Access Compliance Report

Public Rights-of-Way

Intersection ID: 54366	Main Street: CADEN_RD	Cross Street: COLLINS_FORD_RD	Location: W
ADA ID: 130C782E29AF	Ramp Type: BlendTrans1	Initial Pass/Fail: Fail	Overall Compliance: No
Severity Score: 1.25			
Codes/Mitigation Info/Possible Solution		Field Measurements/Component Compliance

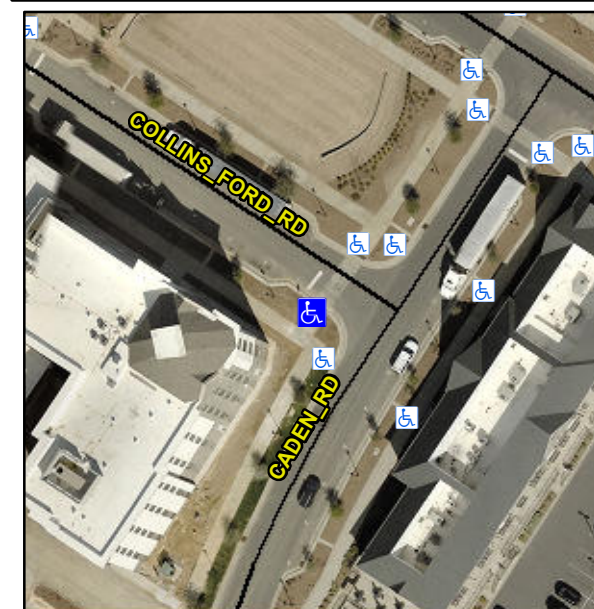
Not Found, R304.5.3

Compliance	Description	Data	Compliance	Description	Data
N/A	Ramp Length (in)	175.0	Yes	BlendTrans Slope (%)	3.3
Yes	Ramp Width (in)	93.0	No	BlendTrans XSlope (%)	4.0
N/A	Flare Type LT	N/A	N/A	Flare Type RT	N/A
N/A	Flare Slope LT (%)	N/A	N/A	Flare Slope RT (%)	N/A
N/A	Flare Traversable LT?	N/A	N/A	Flare Traversable RT?	N/A
N/A	Landing Length (in)	N/A	N/A	DWS Provided?	N/A
N/A	Landing Width (in)	N/A	N/A	DWS Contrast?	N/A
N/A	Landing Slope (%)	N/A	N/A	DWS Length (in)	N/A
N/A	Landing X Slope (%)	N/A	N/A	DWS Full Width?	N/A
N/A	Landing Curb? (Y/N)	N/A	N/A	DWS Offset (in)	N/A
N/A	Shared Landing?	N/A			
N/A	Gutter Ponding?	N/A	N/A	Gutter Slope (%)	N/A
N/A	Gutter Lip Ht (in)	N/A	N/A	Gutter X Slope (%)	N/A
N/A	Painted X Walk1?	Yes	N/A	Painted X Walk2?	N/A
	X Walk 1 Direction	To NE		X Walk 2 Direction	N/A
	X Walk 1 Width (in)	97.5		X Walk 2 Width (in)	N/A
	X Walk 1 Slope (%)	2.6		X Walk 2 Slope (%)	N/A
	X Walk 1 X Slope (%)	3.7		X Walk 2 X Slope (%)	N/A

N/A	Ramp inside XWalk1?	Yes	N/A	Ramp inside XWalk2?	N/A
	Road Slope (%)	3.7		Clear Space?	N/A
	Road X Slope (%)	2.6	N/A	Clear Space to XWalk (in)	N/A
N/A	Any Obstructions?	N/A	N/A	Storm Grate/Utility Hazard?	N/A
	Obstruction Type			Storm Grate/Utility Type	
		N/A			N/A
			Yes	Surface Condition? (G/P)	Good
			No	Curb Slope (%)	14.4

Remove & Replace Curb Ramp With Two New Directional Ramps or Equivalent.
